FIT RUDDER TO HINGE LINE

ATTACH UPPER RUDDER HINGE

HINGE RELATIONSHIP

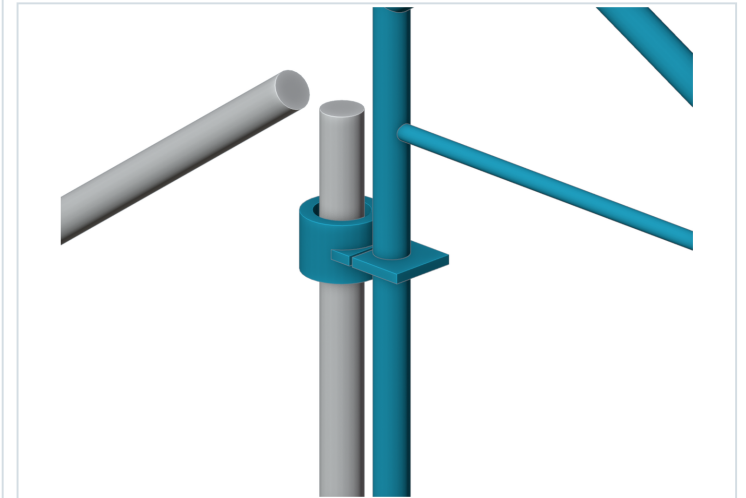
SEE PLAN 24 · ALIGN BOTH HINGES

? VERIFY LOWER HINGE HARDWARE

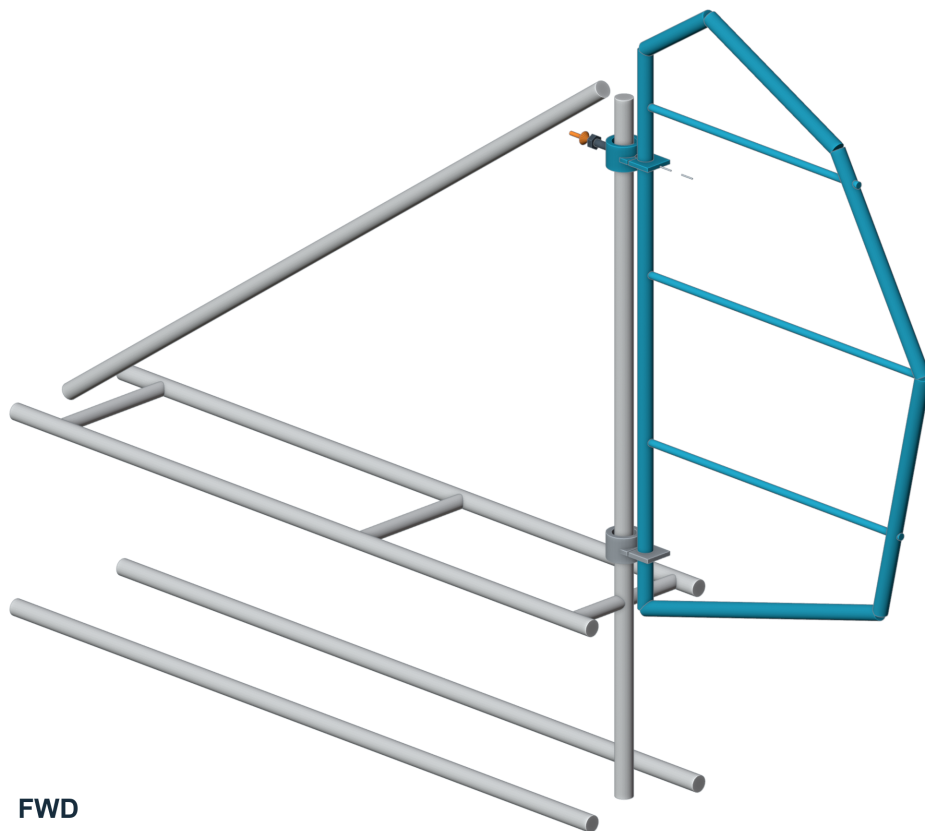
LOWER HINGE HARDWARE UNRESOLVED

FASTENER AXES SHOWN · INVENTORY IS NOT STACK ORDER

CONNECTION DETAIL

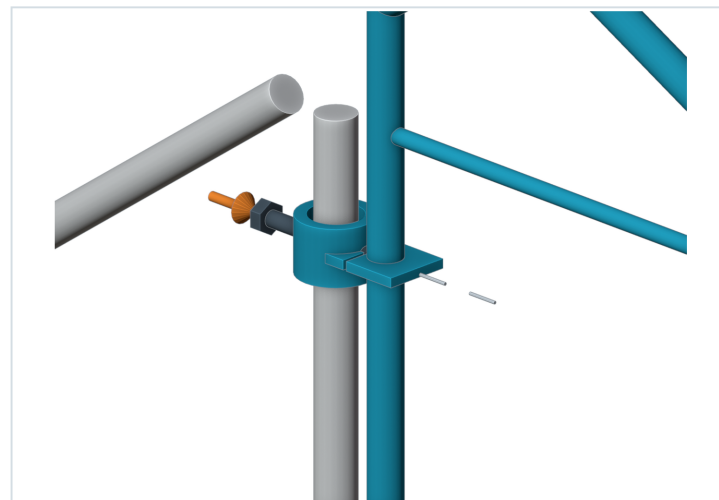
FLYING-WIRE TABS: HEAD + NUT

SOURCE CONFLICT — VERIFY
